Service Bulletin

Bulletin No.: P11219

Subject: Turbocharger Cracks in Inlet Port Center Web Area

Models: 2014-2015 Buick Regal
2013-2015 Cadillac ATS
2014-2015 Cadillac CTS (VIN A)
2013-2015 Chevrolet Malibu
Equipped with Turbocharged 2.0L Engine — RPO LTG

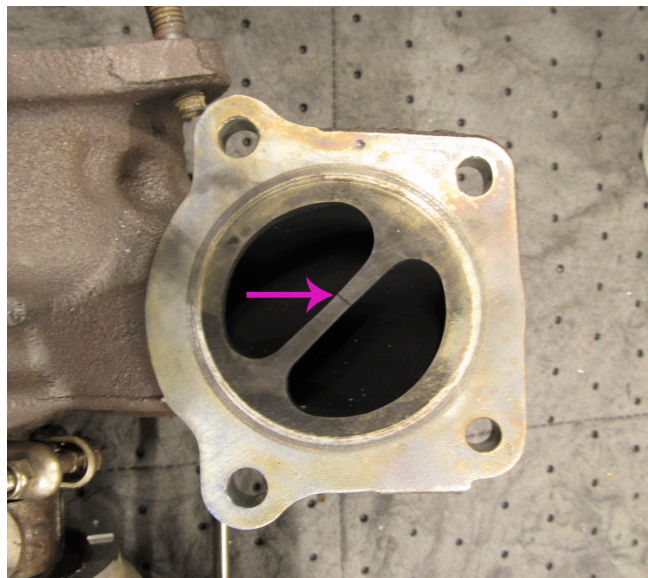
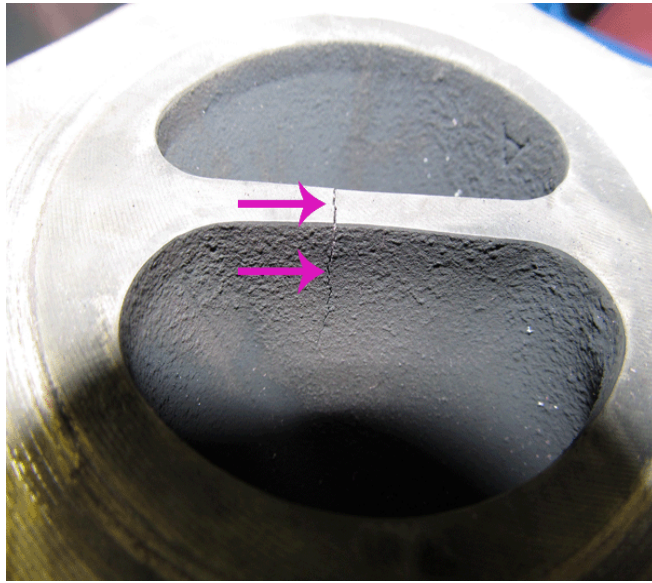
A Service Technician may have removed a turbocharger (TC) during a service procedure and upon inspection may have observed cracks in the TC inlet port center web area.

The appearance of cracks in the center section of the turbocharger **DO NOT** affect the performance of the TC. The TC should not be replaced for cracks in this section.

3804909

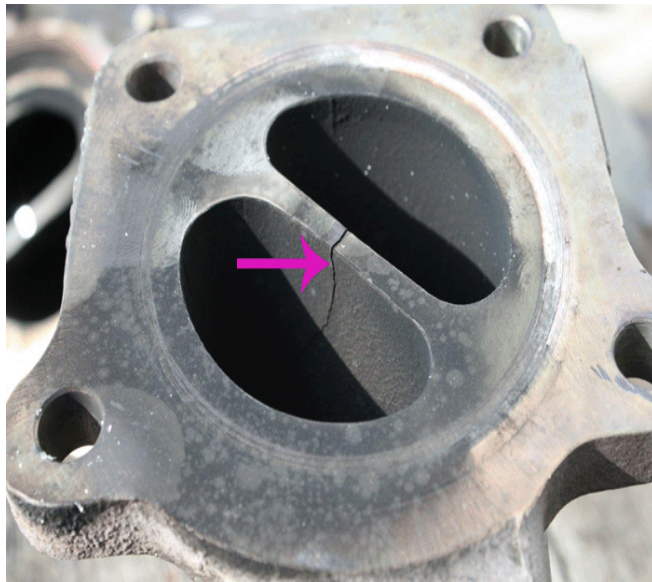
Review the following graphics for views of TC cracks that **DO NOT** require TC replacement:
